Lot 3 Bringelly Road Business Hub, Bringelly Road,
Leppington

Response to Submissions (SSD 10366)

Construction of a new Hardware and Building
Supplies and Garden Centre including Car
Parking and Signage

January 2020

Figure 1:

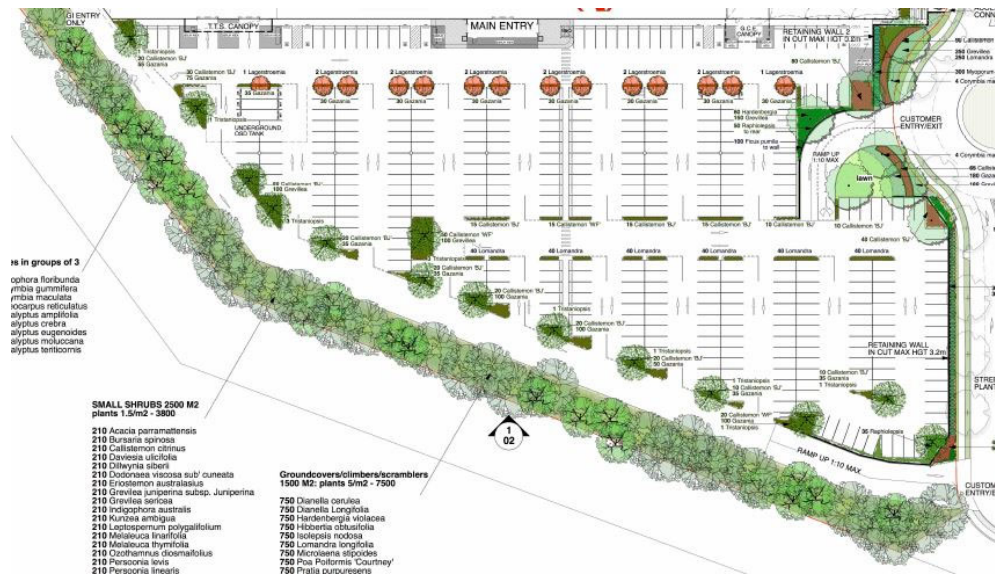
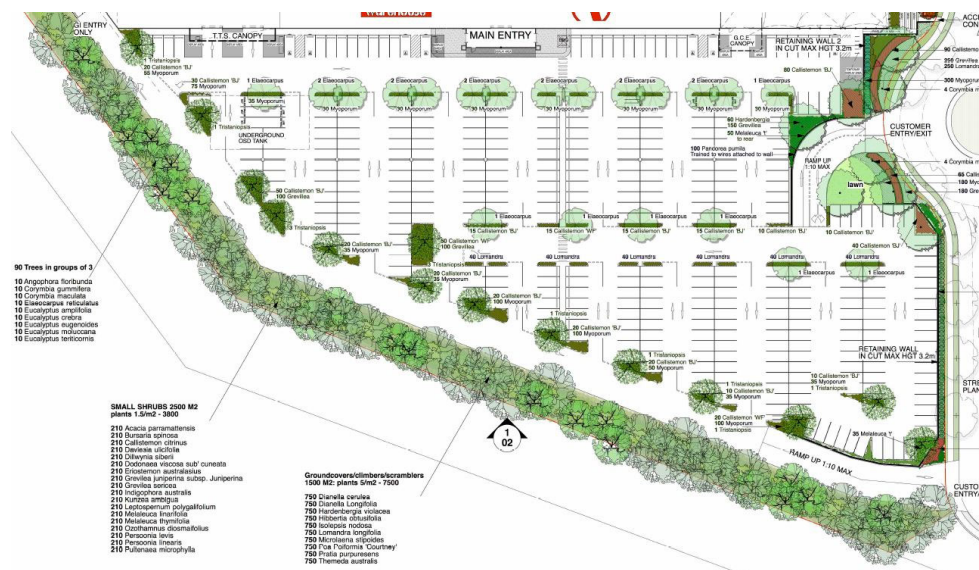
- The provision of tree planting within the hard stand car park area has been increased, with 6 additional Blueberry Ash Trees within the car park which grow to a height of .6 metres.
- The replacement of the previously proposed Crepe Myrtle trees (x 14) within the car park with Blueberry Ash Trees (x 14).

Issue	Response
development which is supported. Given that a large proportion of the site is comprised of the warehouse and open car park, in order to minimise the amount of urban heat caused by the level of hard surface, Council suggests that consideration be given to the provision of additional large canopy trees at the midpoints of the parking bays in the carpark. This will have the added benefit of providing amenity for customer parking. It is noted that this may require a reduction in the available parking spaces though it is noted that the level of parking shown is greater than the minimum required. It is also requested that consideration be given, as a minimum, to provide raised diamond shaped garden beds between car parking spaces so as to provide opportunities for the planting of additional canopy trees within the open at grade car park.	park area, the plan has been updated to add further trees in order to address this concern.

Landscaping	
The Landscape Plan proposes to use species that are not native to the area. This is despite the Notice of Determination for the Concept plan requiring	The landscape plan has been amended to use native plants indigenous to the area.

Initially proposed landscape design for car park

Amended proposed landscape design for car park
